STAFF REPORT: NOVEMBER 16, 2022 MEETING

APPLICATION NUMBER: 22-8118

ADDRESS: 1688 BAGLEY

SCOPE: REPLACE SIDING, REBUILD PORCHES

Figure 11: Dimensioned sketch of porches.

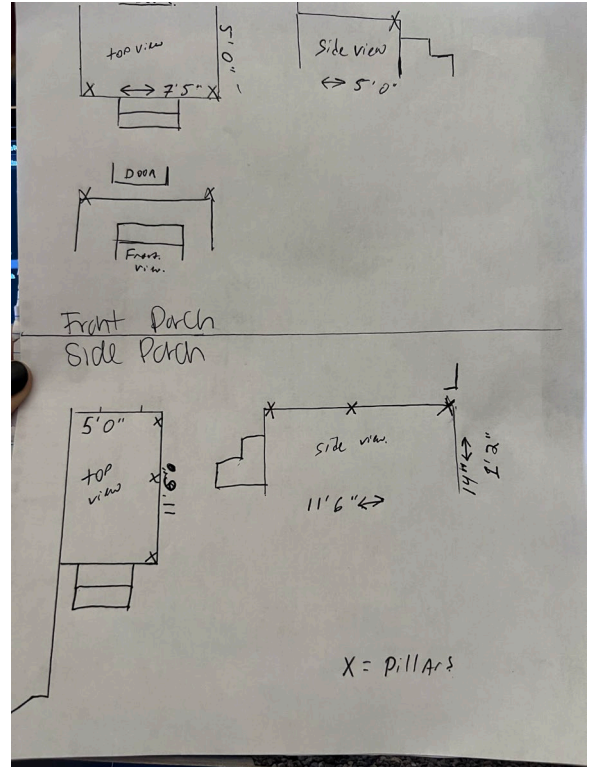
- **Porches:** The proposals for the front and side porch appear to meet the Secretary of Interior Standards for rehabilitation. However, the applicant has not provided sufficient documentation to confirm the design of the replacement columns, foundations and decks will be an accurate and appropriate in-kind replacement.

1. The applicant provide HDC staff with dimensioned photographs or drawings of the existing (removed) columns.
2. The applicant provide HDC with dimensioned and detailed drawings illustrating the construction of the porches including material callouts for approval prior to construction.
3. The applicant provide HDC with documentation of replacement columns, including dimensions, materiality and finish color, for approval prior to construction.
